ADDENDUM: THREE

ISSUE DATE: 03 November 2017

PROJECT TITLE: **INDEFINITE DELIVERY CONTRACT FOR ROOFING CONSTRUCTION SERVICES**
 Francis Marion University
 IDC Project No.: H18-D090-PD

Representative Project:
ERVIN DINING HALL RE-ROOF PROJECT
 Francis Marion University
 IDC Project No.: H18-N069-PD

1 ROOF PLAN
A1 3/32" = 1'-0"

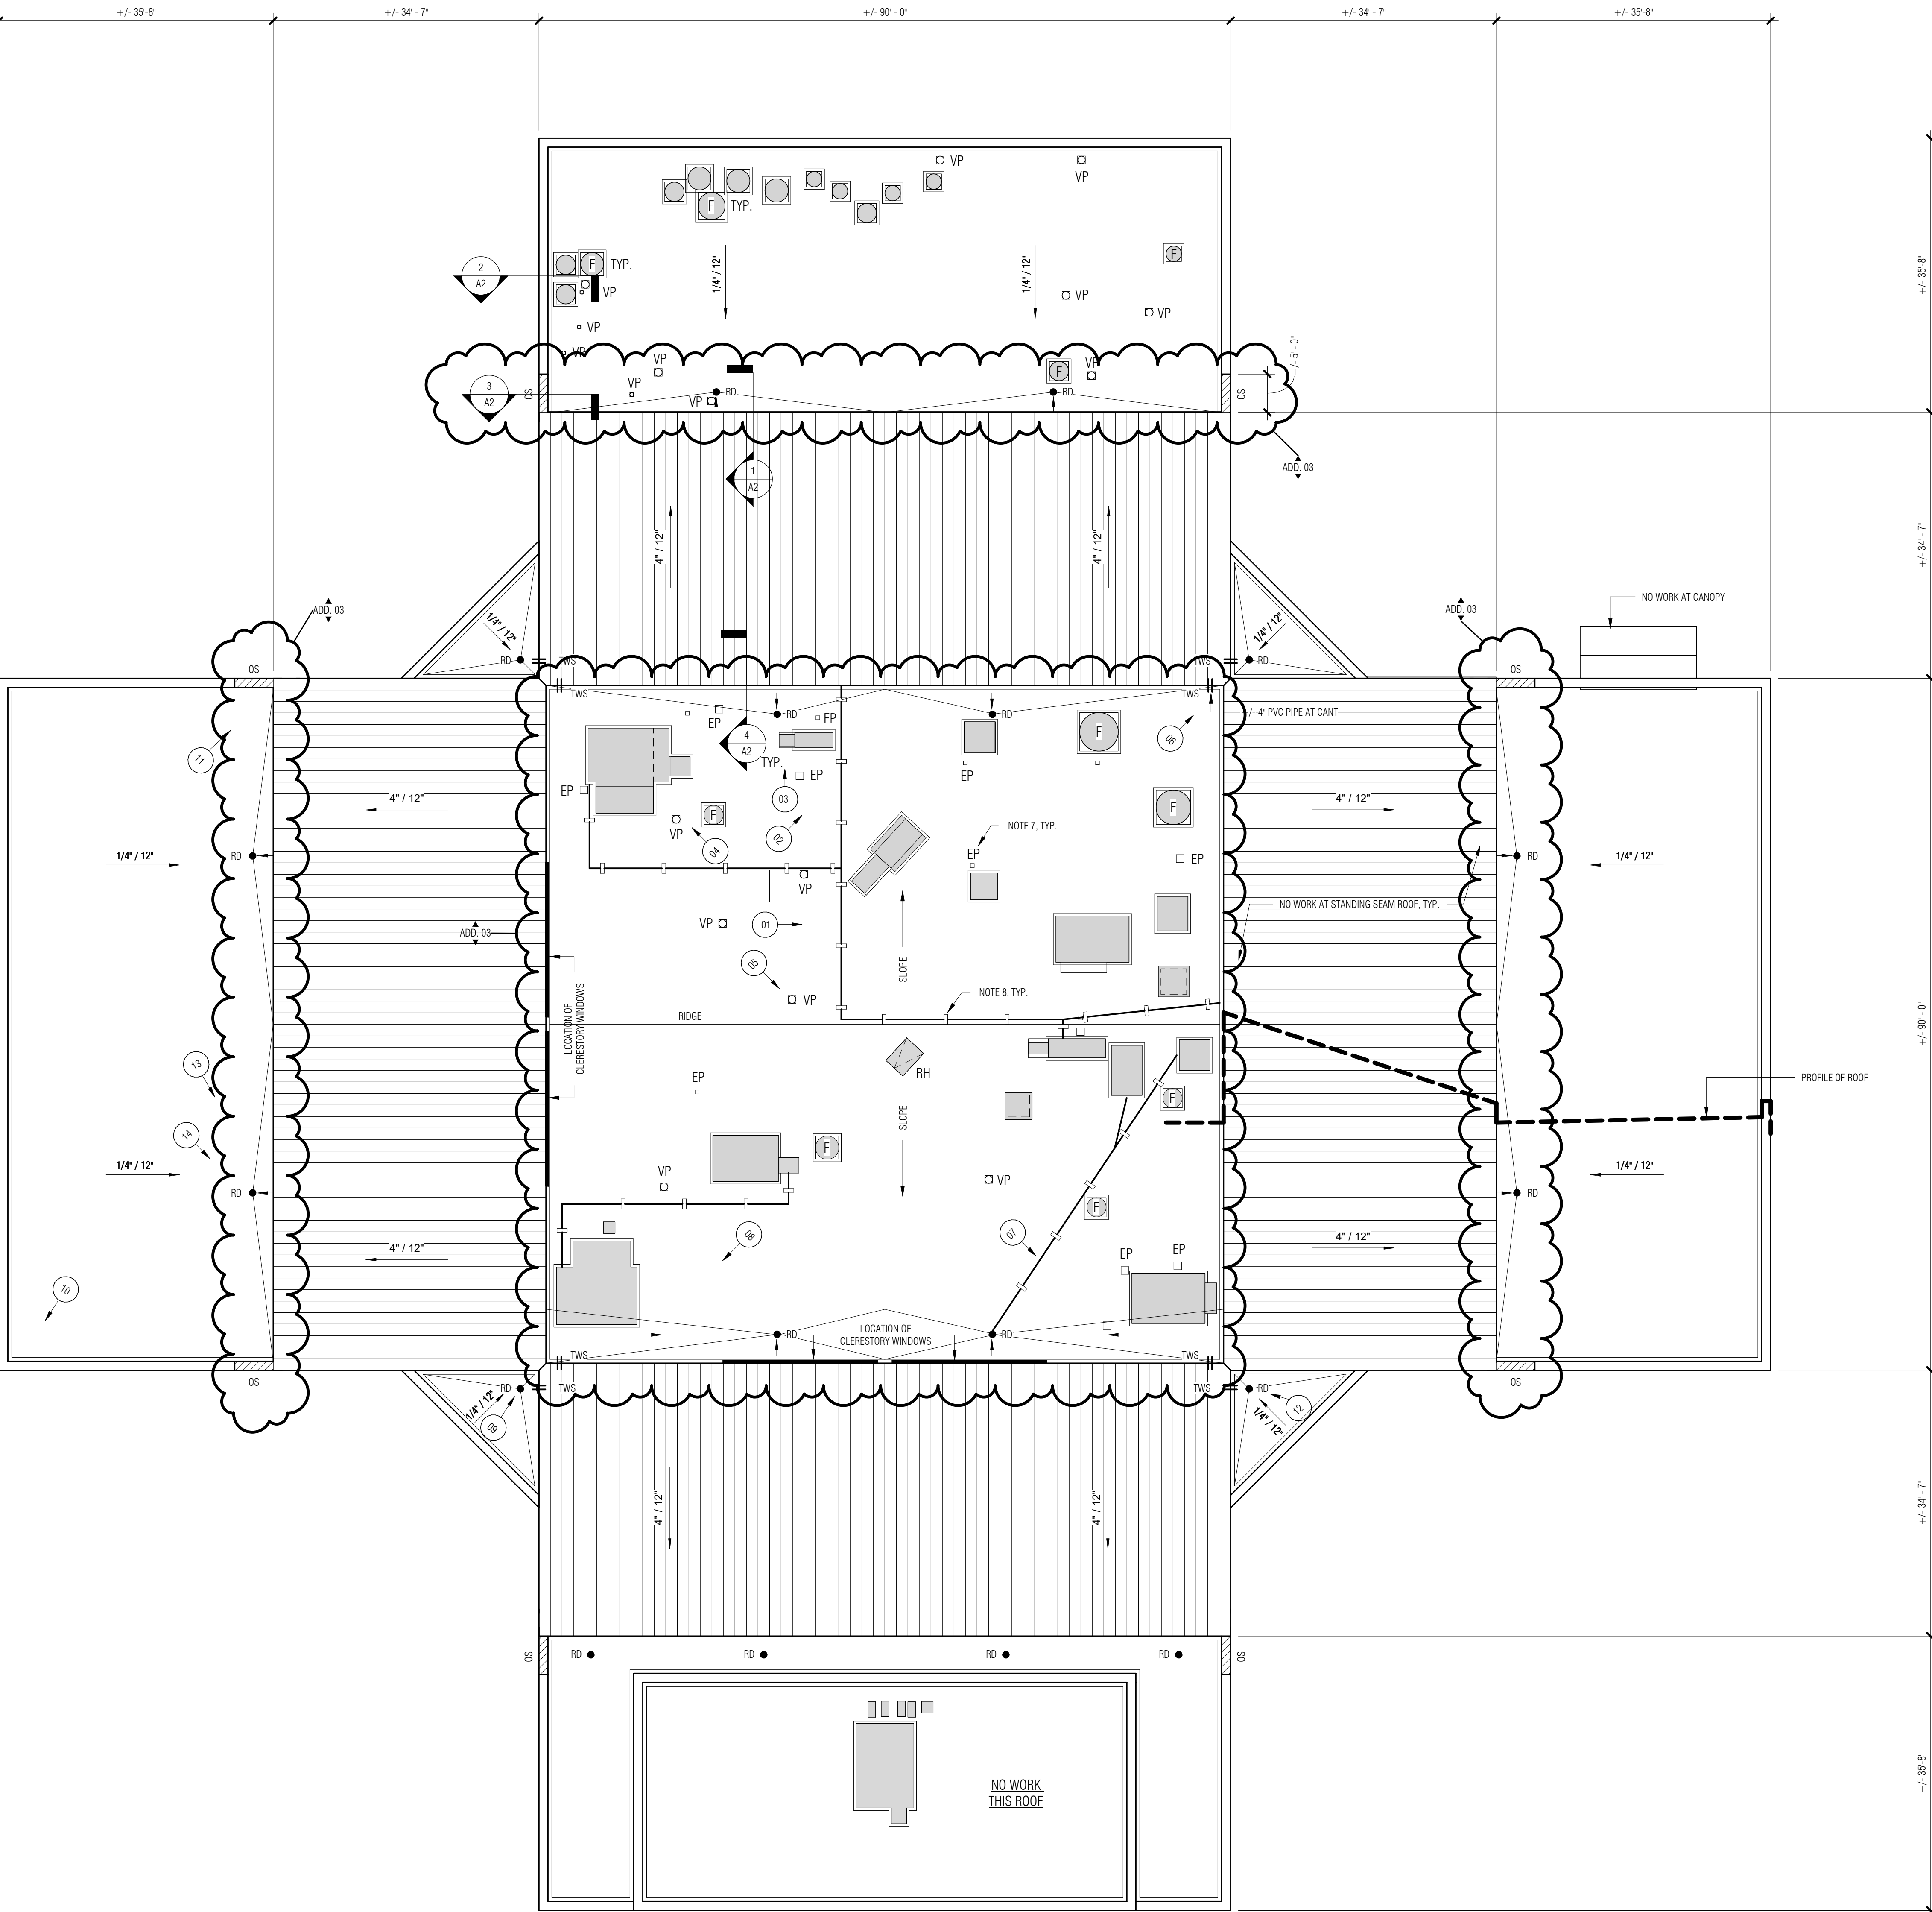
1. DRAWING A1 – ROOF PLAN:

A. Replace Drawing A1 with the attached Revised Drawing A1.

1) Revisions include, but are not limited to, the following:

- a) Added General Notes 7 & 8.
- b) Added Electrical Penetration symbol to legend.
- c) Corrected existing roof drain locations.
- d) Corrected existing ridge location and slopes.
- e) Indicated additional existing roof piping.
